TENNESSEE VALLEY AUTHORITY

In the Matter of the	)	Docket Nos. 50-259
Tennessee Valley Authority	)	50-260
		50-296

By my letter to you dated March 4, 1982 we submitted a request for technical specification change, TVA BFPN TS 172, to allow single recirculation loop operation of the Browns Ferry Nuclear Plant. Additionally, by my letter to you dated September 3, 1982 we submitted a response to an NRC request for additional information regarding single-loop operation. Enclosed is our response to the NRC request for additional information forwarded to TVA by letter from D. B. Vassallo to H. G. Parris dated November 8, 1982.

### Browns Ferry Nuclear Plant Units 1, 2, and 3 Response to Request for Additional Information Single Loop Operation

FIGURE 1: Single loop data at 50.7% flow, 61.1% power.

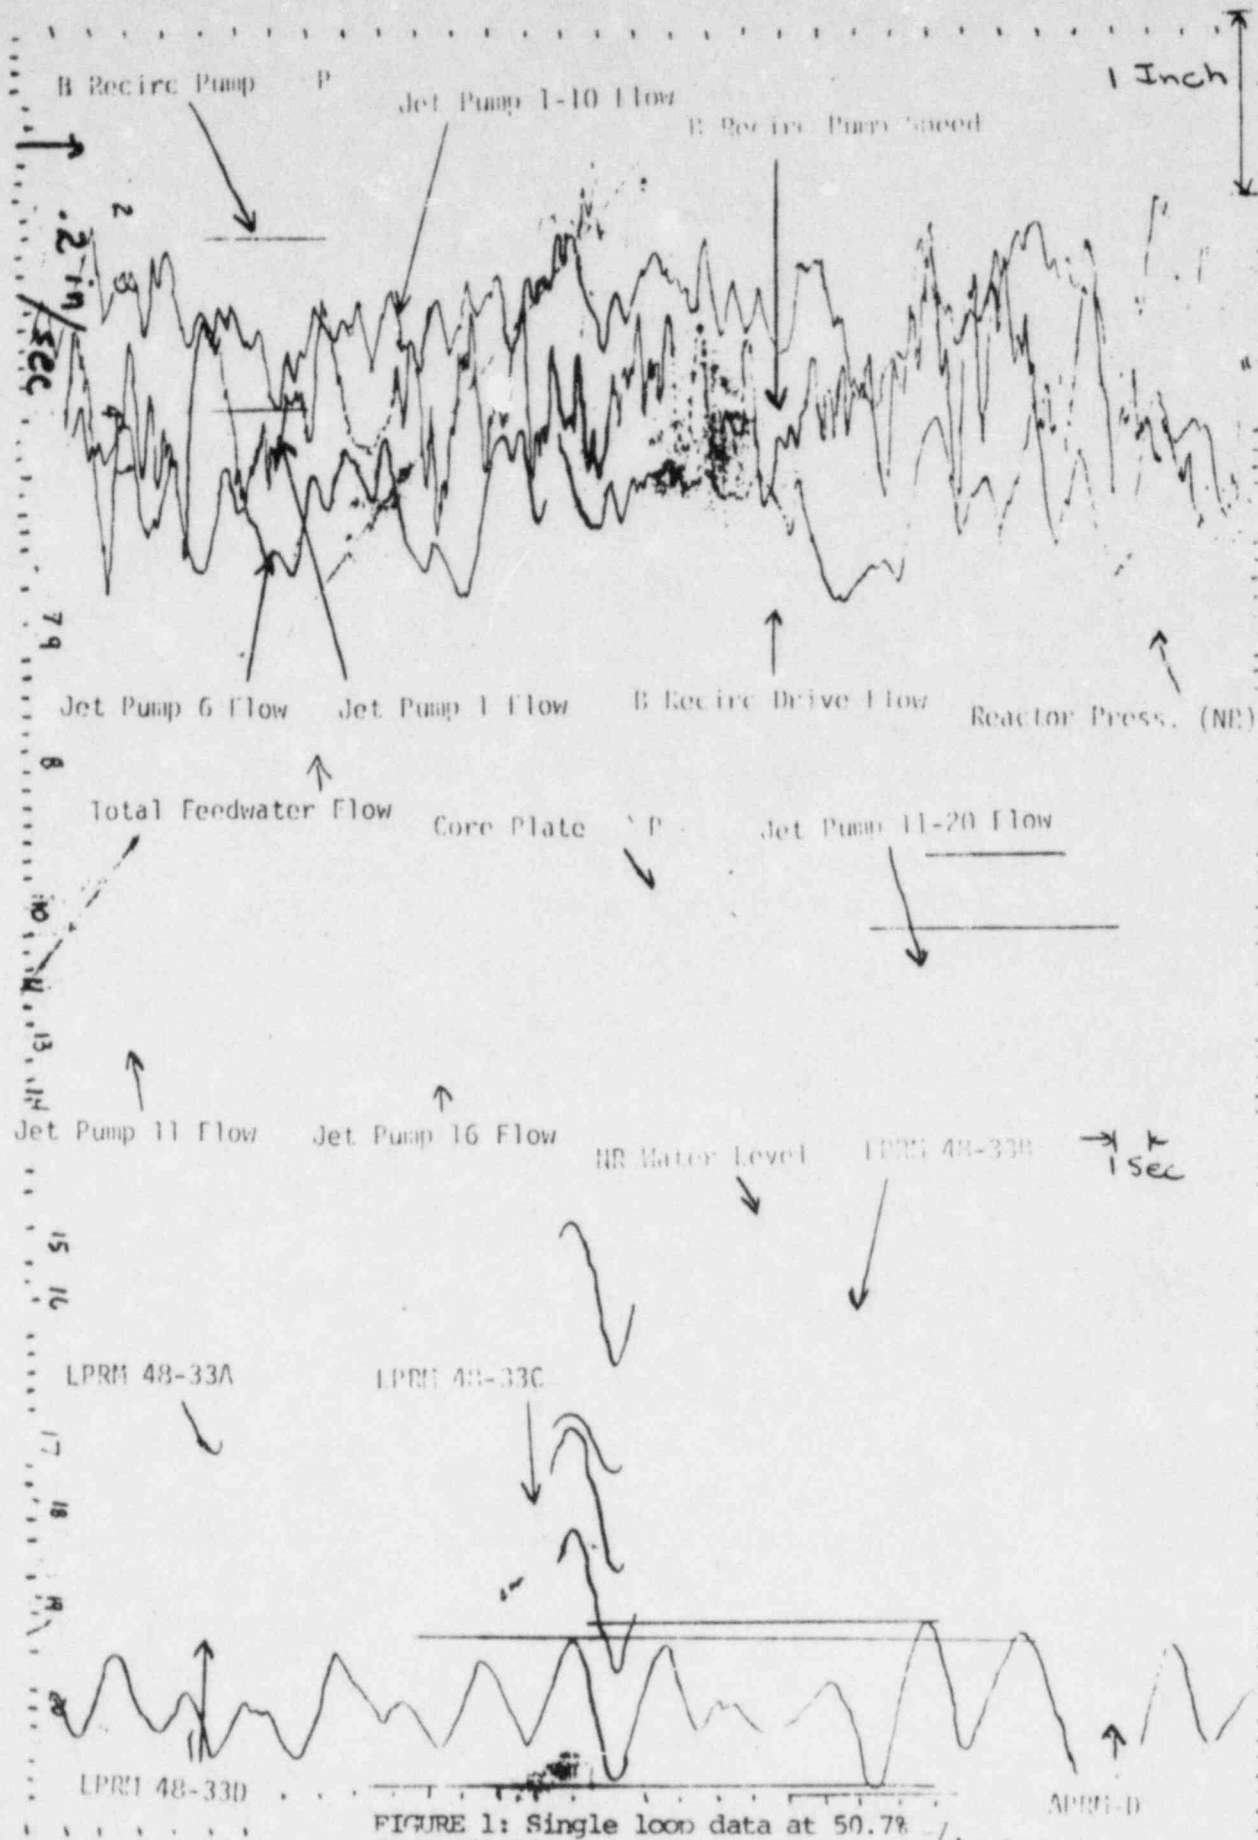
The frequency of the oscillation at Browns Ferry Unit No. 1 (BF1) (0.3-0.5 Hz) is essentially the same as the characteristic frequency of BWR density-wave oscillations. The postulation that the increased flow noise is primarily due to the increased flow rate and inherent flow noise in the active jet pumps is plausible but we require substantive proof that this is the case. Experimental or calculational results which predict that the observed flow fluctuations can produce the observed magnitude and frequency of neutron flux would provide sufficient proof as long as the power-void feedback can be shown to be small. Calculational results which predict the observed frequency for the BF1 conditions or experimental results which are extrapolated to the BF1 conditions would provide sufficient proof. For arguments based on calculational methods, the codes used, boundary conditions, and calculational assumptions should be provided together with major input and output values. For arguments made based on experimental results, experimental values should be provided and the assumptions made to extrapolate these results to BF1 conditions should be explained.

Figure 1 is a strip chart recording of plant parameters obtained during Browns Ferry single-loop testing in the fall of 1978. Pertinent data has been manually enhanced due to poor quality of the original. Figure 2 consists of a manual reproduction of the same data traces neglecting what are determined by visual inspection to be higher order effects for the sake of clarity. Inspection of the active jet pump 1-10 total flow and APRM D signals shows clear dependence of one signal upon the other. The magnitude of flux in response to flow exhibits a gain in amplitude which is the expected behavior when driven at or near the resonant frequency of approximately 0.5 Hz. The observed core flow variations therefore could produce the observed flux variations.

FIGURE 3: COMPARISON OF FLUX VARIATIONS TO OPERATING CONDITIONS

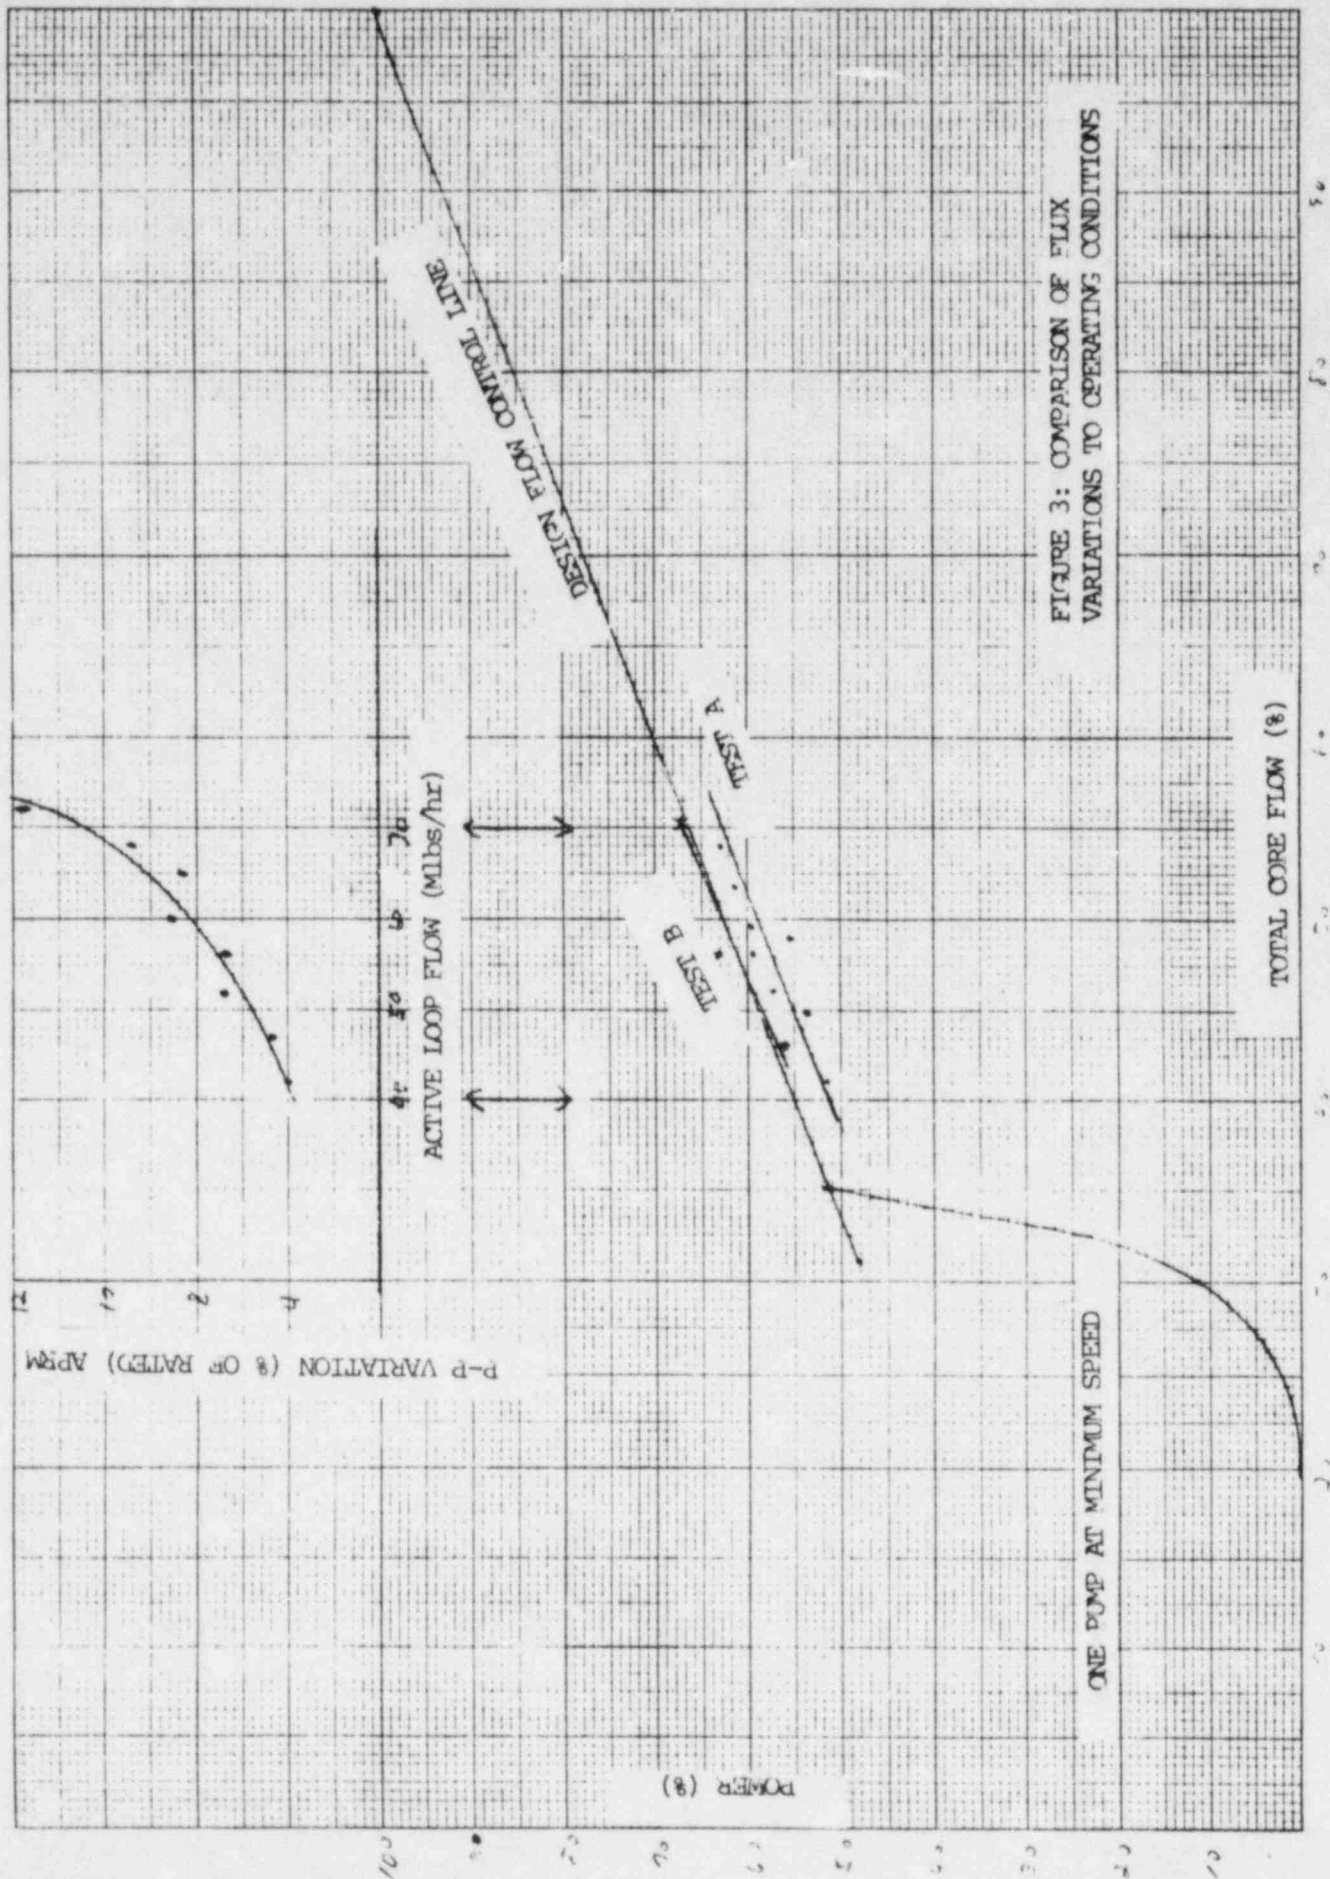
Provide a power flow map which incorporates data points of the BF-1 single-loop operating history. Clearly designate the range where oscillations were experienced.

Figure 3 contains a power flow map for the Browns Ferry single-loop experience of the fall 1978. Total core flow is a calculated value which conservatively accounts for inactive loop backflow, and it therefore should be recognized that there is some inaccuracy in this value. This is particularly true in the region of 45-50 percent of rated flow where backflow is first established. The active loop flow axis for the APRM peak-to-peak variation graph is placed to approximately correspond with the associated total core flow values for the operating map.
